Product Advisory

Product Family:	Productivity2000	Number:	PA-P2K-012
Part Numbers:	P2-16TR rev C2	Date Issued:	09/22/2021
Subject:	POTENTIAL SAFETY CONCERNS Urgent-Mandatory Hardware Replacement	Revision:	Rev. C

Follow-up to Product Advisory PA-P2K-012, Rev. B dated 09/22/2021

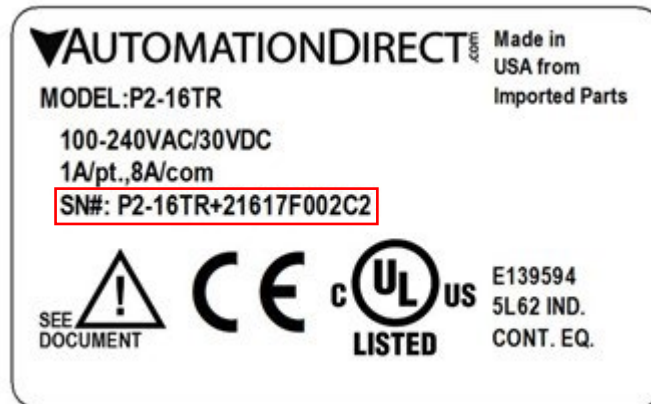
Important Notice A hardware replacement is required for every P2-16TR rev C2 module purchased between July 6, 2021 and August 26, 2021. P2-16TR rev C2 modules are identified by serial numbers on the Productivity2000 module product label as shown below. The module revision can also be found in Productivity Suite, Hardware Configuration, CPU, click on the P2-16TR module, Module Info.

- P2-16TR+xxxxxFxxxC2 – Note, the last two characters denote the product revision. Only if the last two characters are “C2”, then this module must be replaced.

Description of Problem The modules outputs can go to unpredictable states.

Solution for Problem It is necessary to replace all P2-16TR rev C2 modules. Please immediately visit <https://www.automationdirect.com/myaccount/returns> to submit a Product Returns form which creates the RMA, automatically generates your replacement order, and provides you with a shipping label to return the defect product. Please be sure you are logged in to the account from which the module was purchased. Replacement orders may take 2-10 business days to process before shipment. It is essential the affected hardware be returned to AutomationDirect.com within 10 days after the receipt of the replacement module.
